**From:** Tim Buckingham [tim@studioe.co.uk]  
**Sent:** 03 October 2006 11:23  
**To:** Swanepoel, Marilet  
**Subject:** 1151 October Gallery  
**Importance:** High

## OCTOBER GALLERY

PROPOSED ACCESS  
DOOR MOULDING  
PROFILE  
DRAWING

1151 PL19

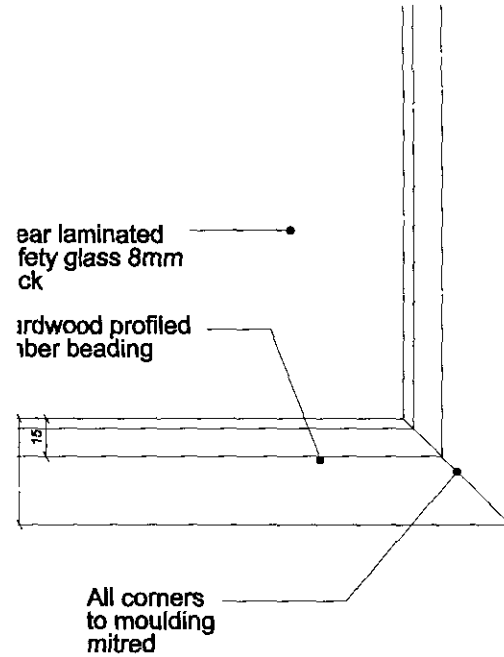
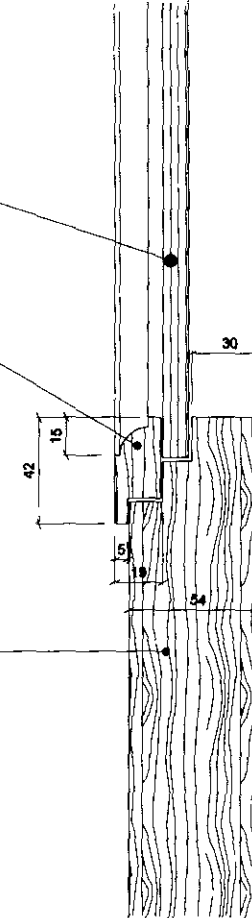
We note the comment to the profile and material to the new lintel above the door opening and look forward to confirmation of your receipt of this information and recommendation of the scheme for approval.

I had a discussion with Hannah (design officer) this morning and she requested that the new door should be single glazing as double glazing would appear to modern for this listed building. Would you be able to confirm this in writing.

Furthermore, details are required of the moulding panels of the new door. Would you please email me

*Single Glazing could be used to the new entrance door vision panels in lieu of double glazing as suggested by the Conservation Officer.*

Attached is a sketch of the molding panel profile of the proposed new door at scale 1:2 as requested and numbered PL 019
